APPLICATION FOR MODIFICATION ASSESSMENT REPORT

Application Number:	Mod2025/0240
---------------------	--------------

Responsible Officer:	Phil Lane
Land to be developed (Address):	Lot 151 DP 6937, 40 Sunrise Road PALM BEACH NSW 2108
Proposed Development:	Modification of Development Consent DA2021/0900 granted for Construction of a dwelling house including a swimming pool and spa
Zoning:	C4 Environmental Living
Development Permissible:	Yes
Existing Use Rights:	No
Consent Authority:	Northern Beaches Council
Land and Environment Court Action:	No
Applicant:	Susan Elizabeth Rothwell

Figure 1: Area above 8.5m height plane highlighted in purple

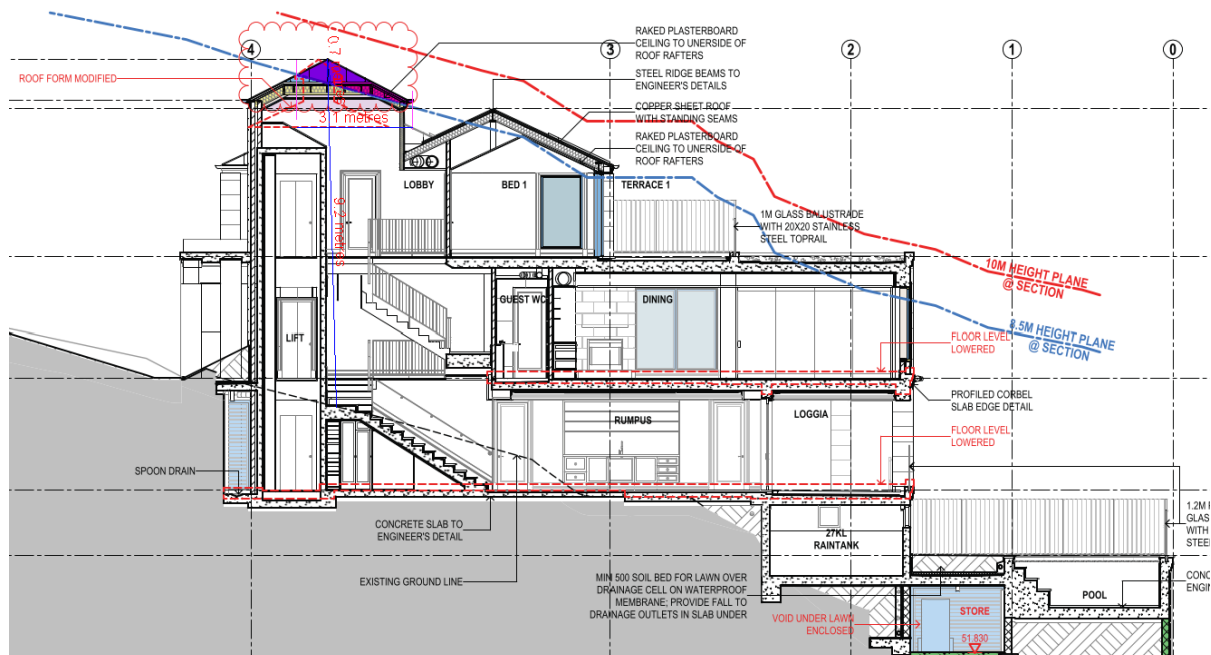
Comment: The areas of the dwelling house that protrude above the 8.5m height plane are confined to minor portion of the lightwell at the front of the dwelling. The breaches occur for a horizontal length of 3.1m for a vertical length of 0.7m on the roof terrace. Figure 3 (Section 1) below depicts the areas that protrude above the 8.5m height plane. These areas above the 8.5m height limit are considered minor given the low percentage these areas demonstrate overall versus the high percentage of the building demonstrates compliance with the 8.5m height control.
